NM NIAGARA NINE MILE POINT MOHAWK NUCLEAR STATION

EDC NO	2	E	1	0	1	3	0	REV
--------	---	---	---	---	---	---	---	-----

8/88
 NEL-050
 ENGINEERING DESIGN CHANGE

LABELING CHANGES AND DRAWING CHANGES TO CLARIFY LABELS ON Uninterruptible Power Supplies FOR CLARIFICATION AND CONSISTANCY. AND TO REFLECT AS BUILT CONDITIONS.

SWECNO: 1-560-229-021

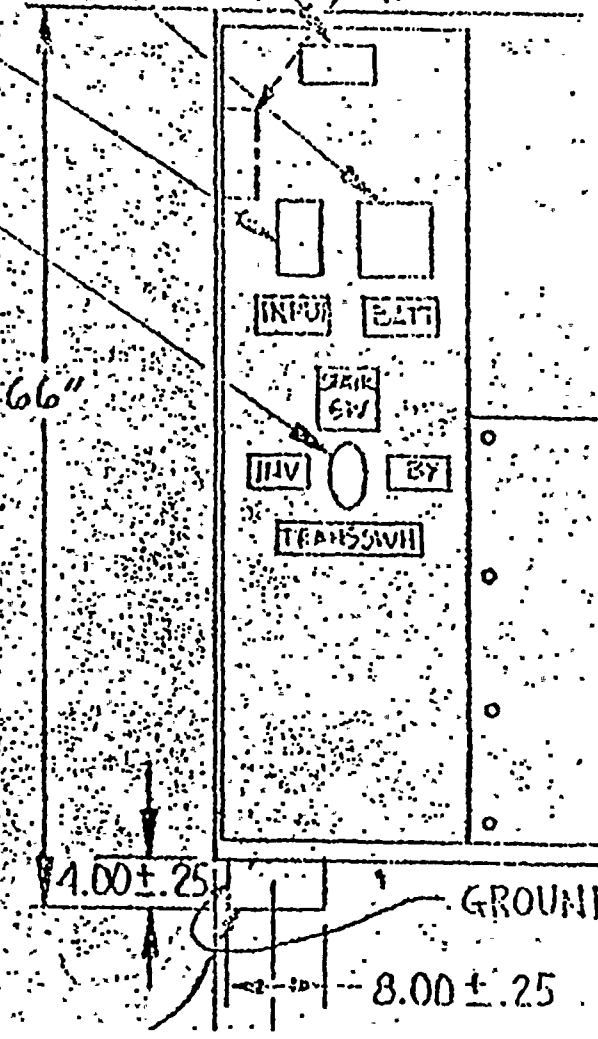
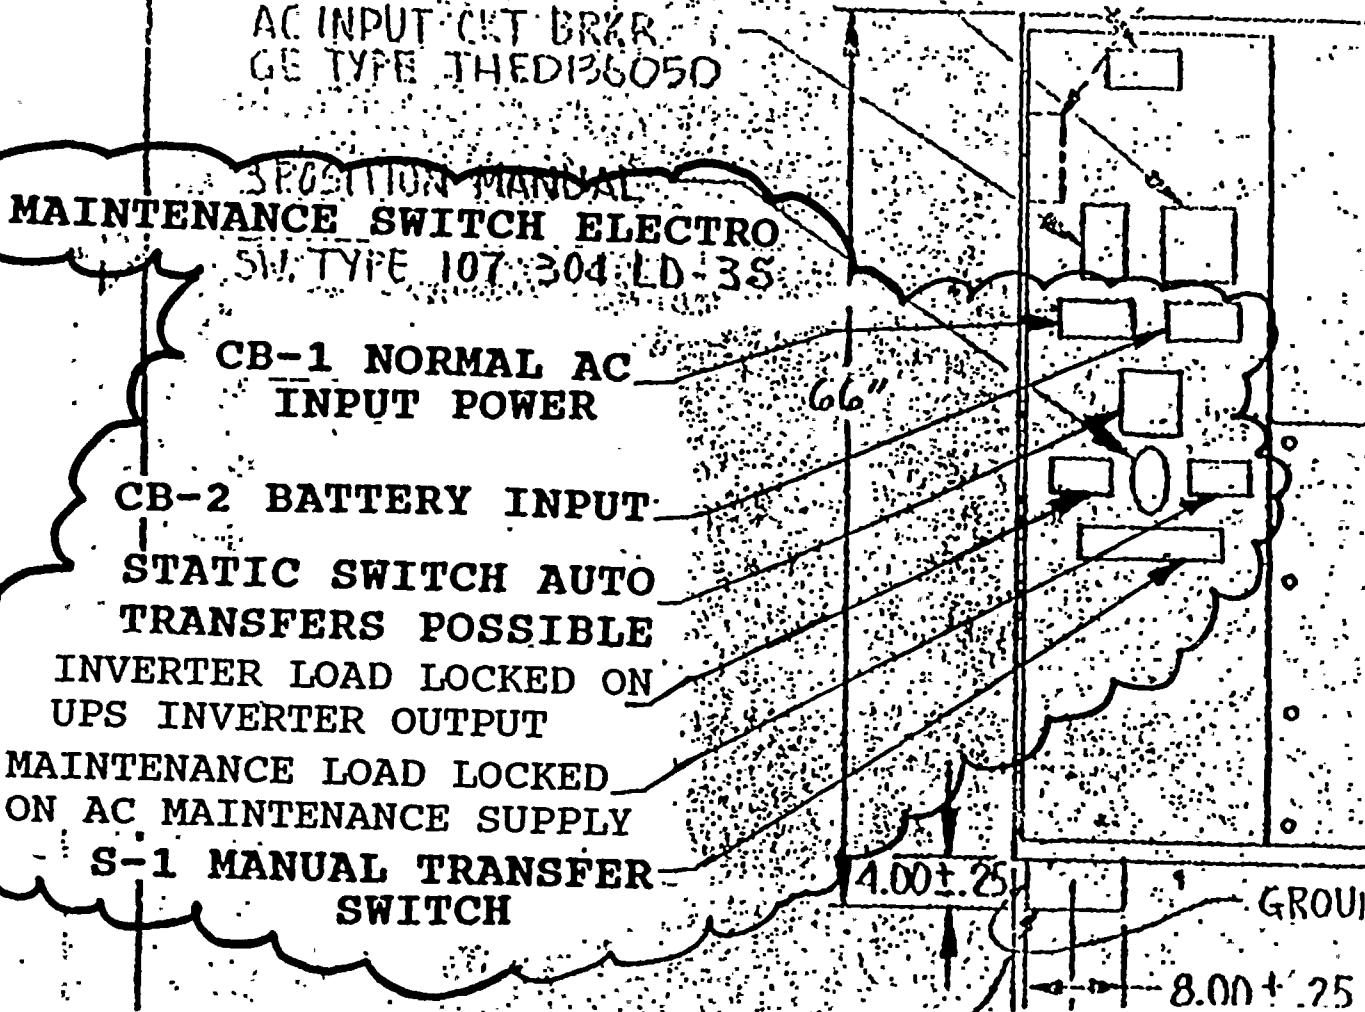
FROM:

3 POSITION MANUAL
BYPASS SWITCH ELECTRO
SW TYPE 107-304-LD-38

TD:

SWECNO: 1.560-229-024

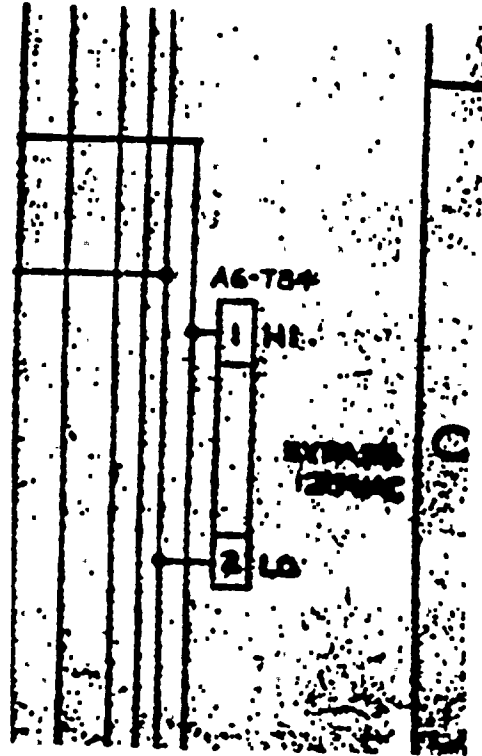
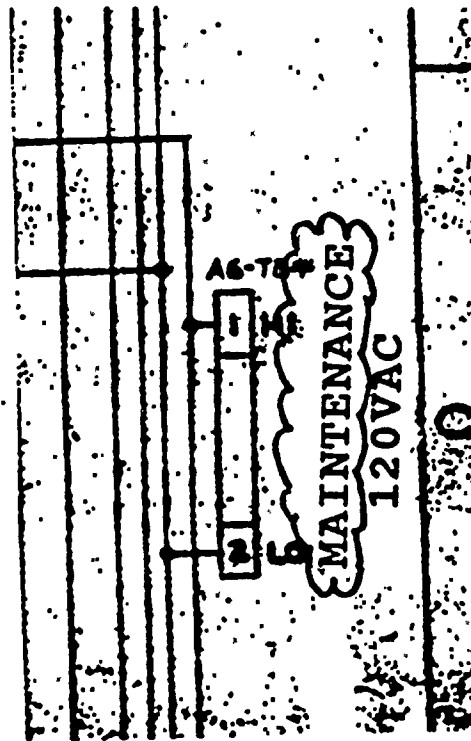
FROM:

TO:

SWECNO: 1.560-229-026

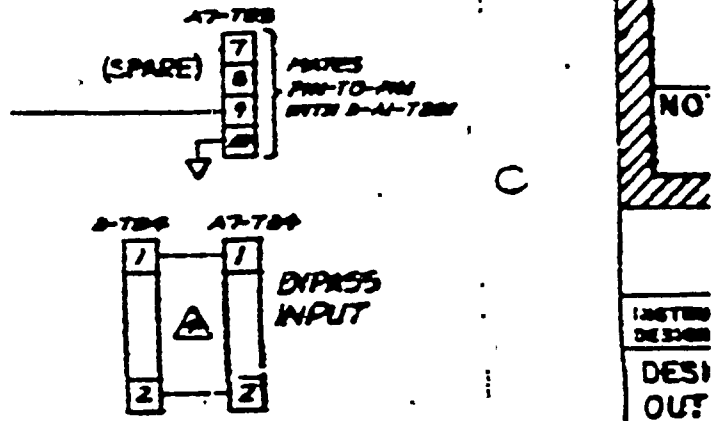
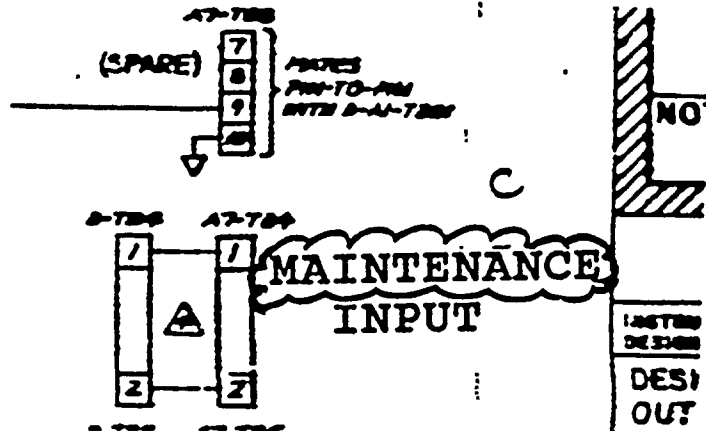
FROM:

TO:

SWELNO: 1.560-229-027

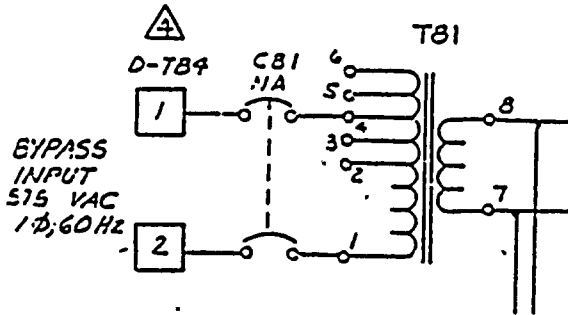
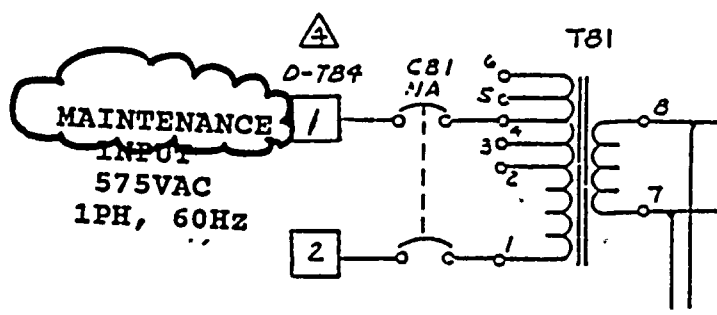
FROM:

TO:

SWECNO: 1.560-229-027

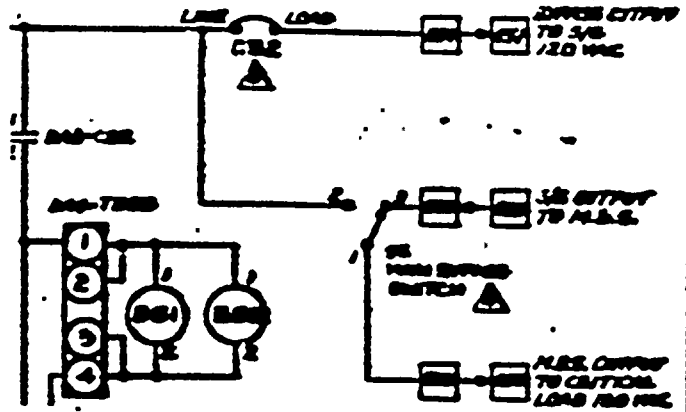
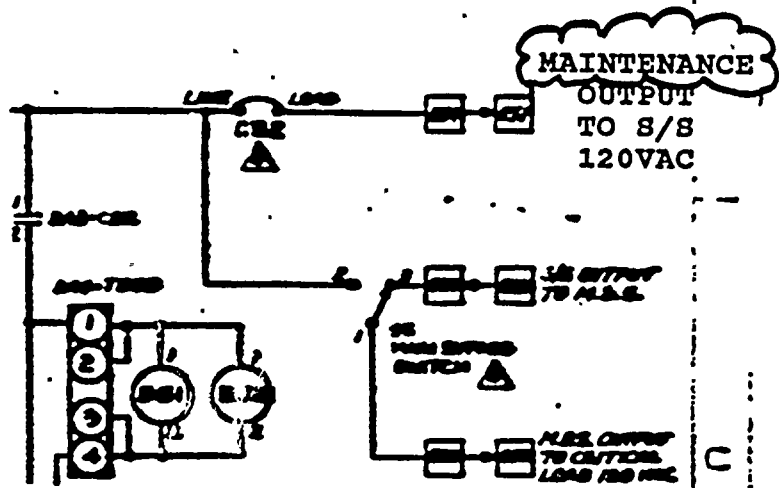
FROM:

TO:

FROM:
 SWELNO: 1.560-229-028

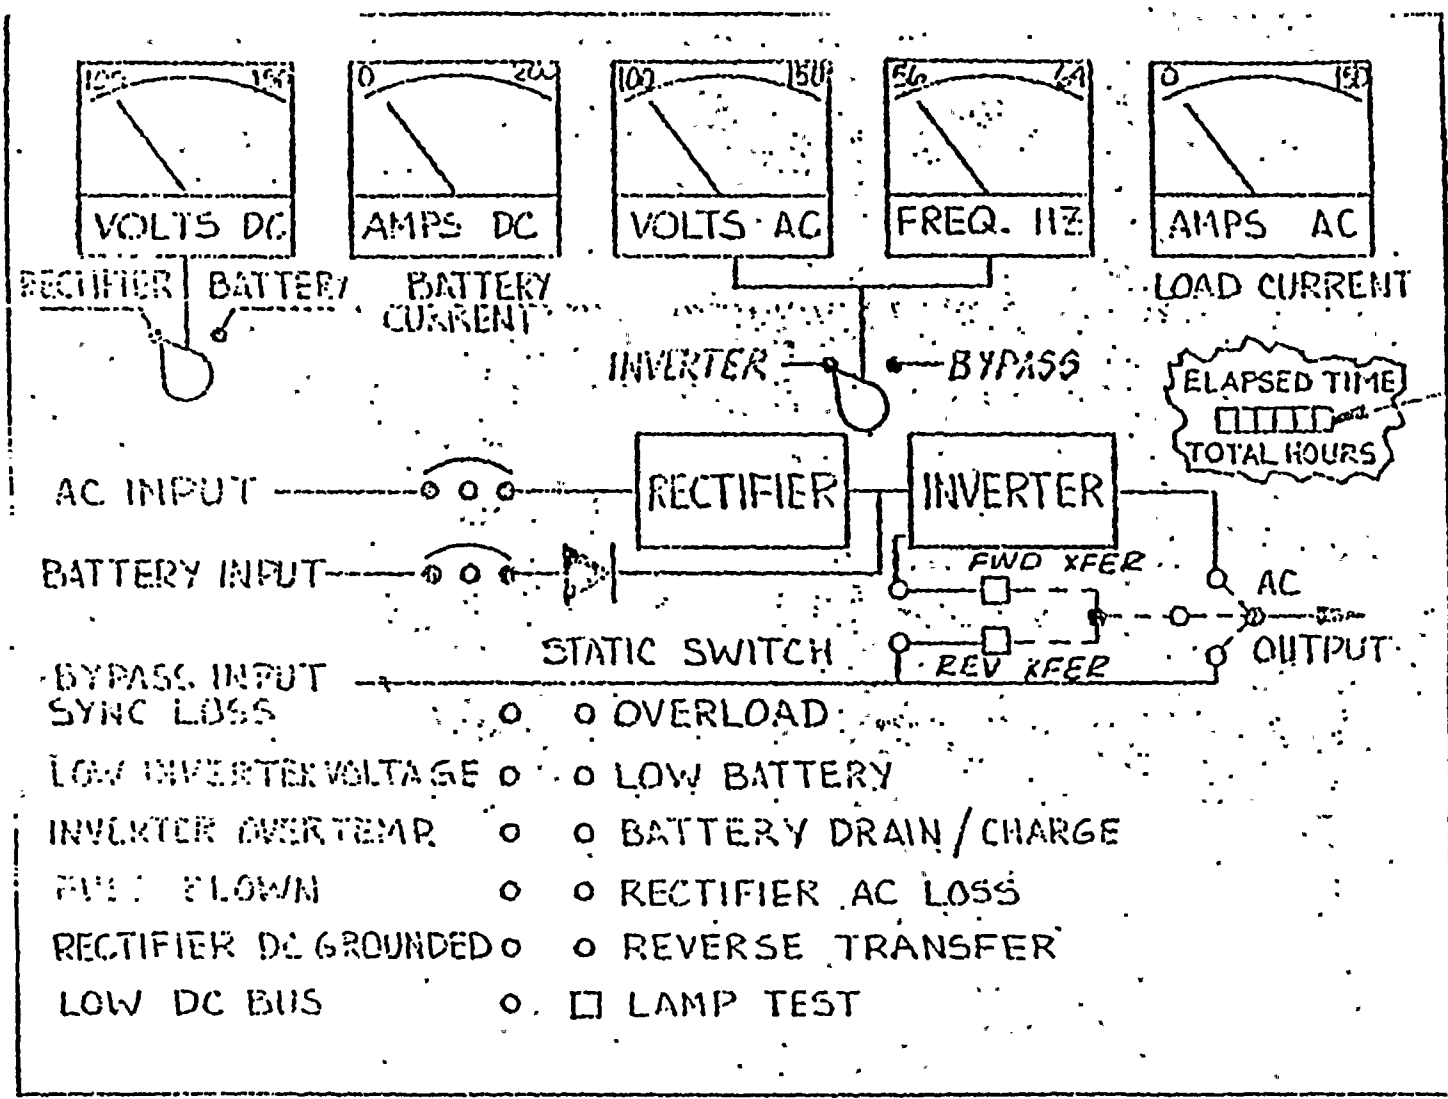
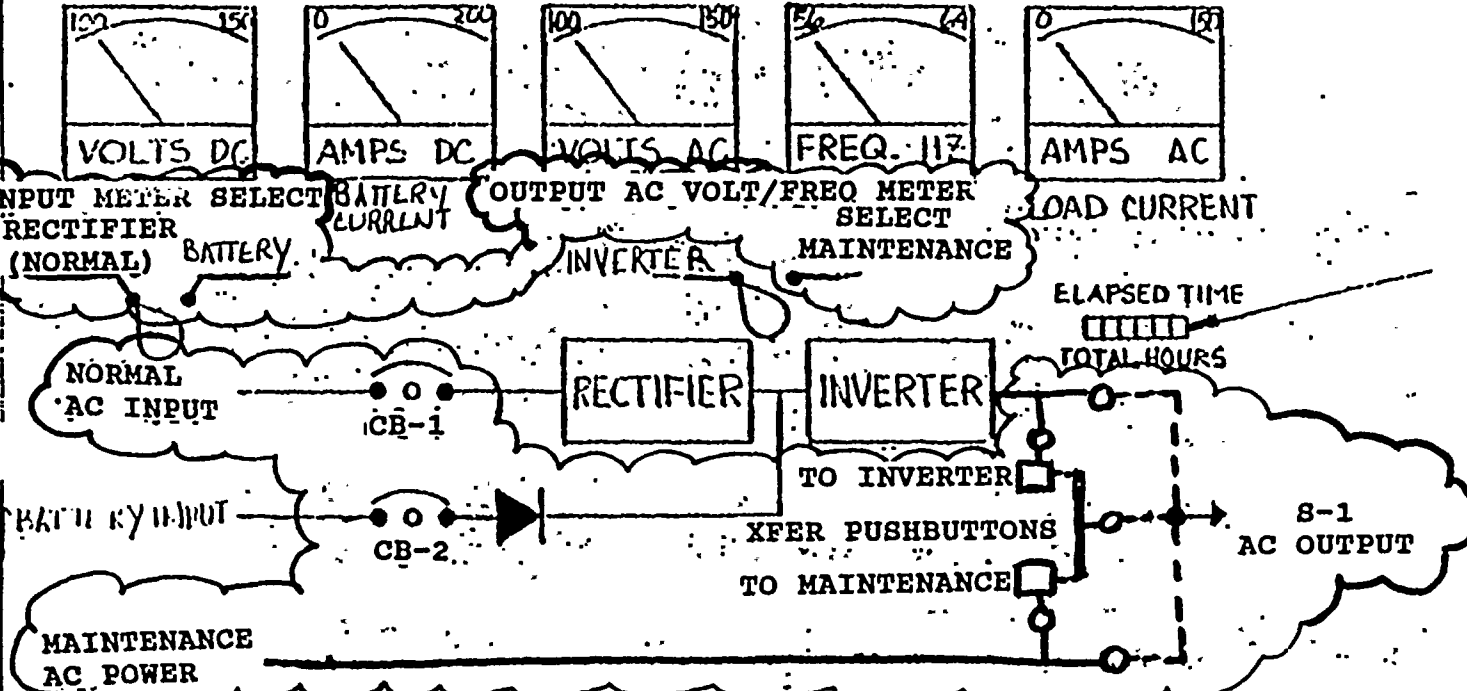
CONTROL PANEL

SWEETNO: 1.560-229-028
 TO:

- SYNC LOSS ○ ○ OVERLOAD
- LOW INVERTER VOLTAGE ○ ○ LOW BATTERY
- INVERTER OVERTEMP. ○ ○ BATTERY DRAIN/CHARGE
- FUSE BLOWN ○ ○ RECTIFIER AC LOSS
- RECTIFIER DC GROUNDED ○ ○ REVERSE TRANSFER
- LOW DC BUIS ○
- ALARM RESET/LAMP TEST

SNECNO: 1.560-229-029

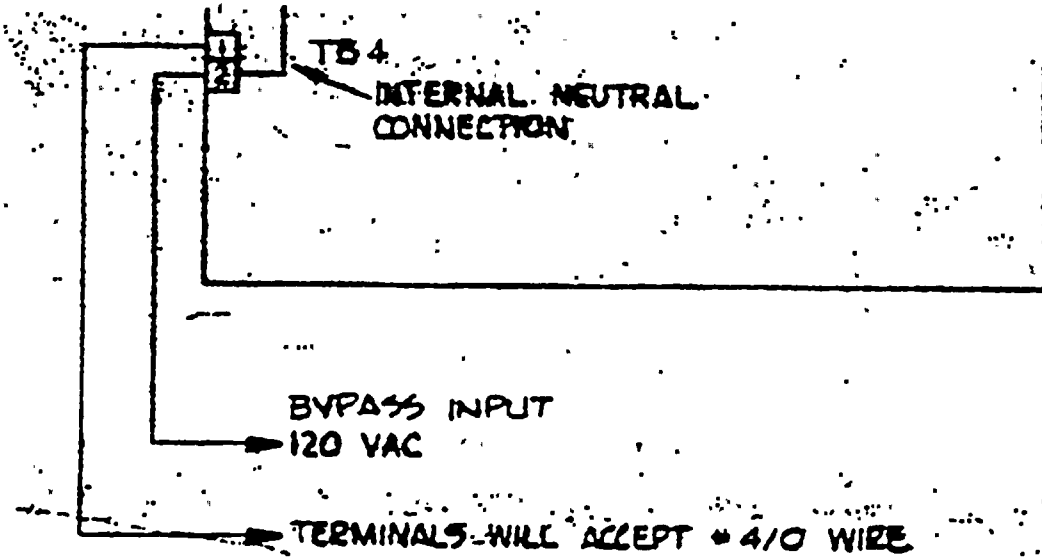
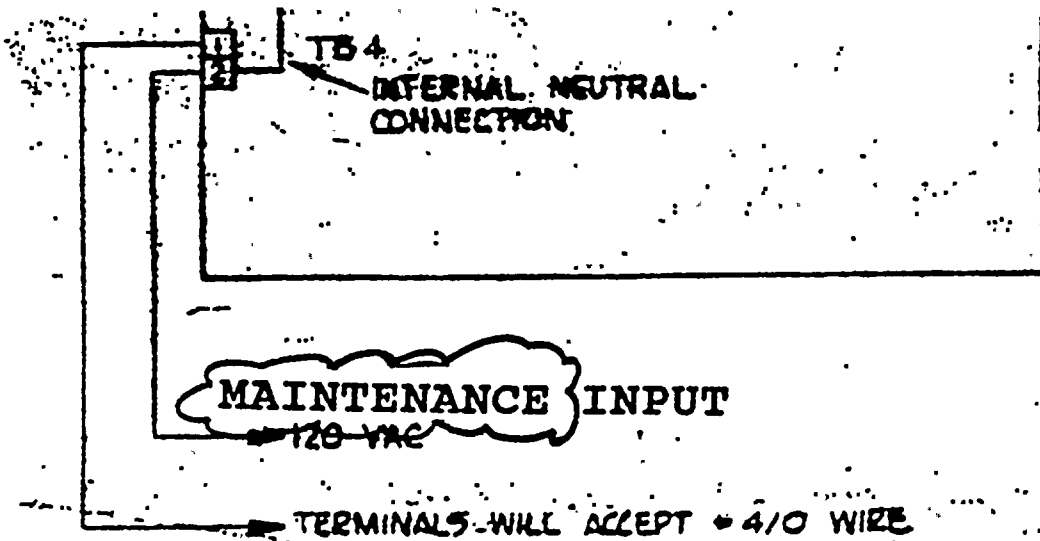
FROM:

TO:

NAMEPLATES SHOULD BE MADE ON BLACK PLATES WITH WHITE CORE.

NAME PLATES SHOULD BE ATTACHED WITH ADHESIVE.

FIELD TO ADJUST DIMENSIONS OF NAMEPLATE AND LETTERING TO PARTICULAR FIELD CONDITIONS.

WHEN REPLACING A NAMEPLATE WHERE POSSIBLE REMOVE EXISTING NAMEPLATE OR LABEL.
